STAR ONLINE PUBLICATION

Case Number: S2223000066

Symptom/Vehicle Issue: Power Top Rattles Over Bumps And Rough Roads.

Fig 2 Screw locations.

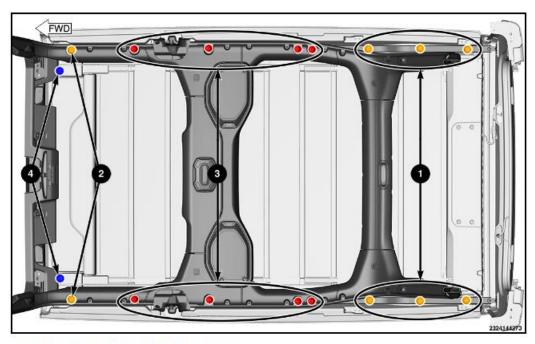
Discussion: The power top system is fastened to the sport bar with 16 screws. Verify the torque for these fasteners is correct. Refer to the attached torque table and fastener location images below. If screw torque is not with in specification and is low replace the screw with updated fastener(s). 06513816AA for rear aperture and front screws (yellow locations in Fig 2). 06512210AA for the body screws (center red locations in Fig 2).
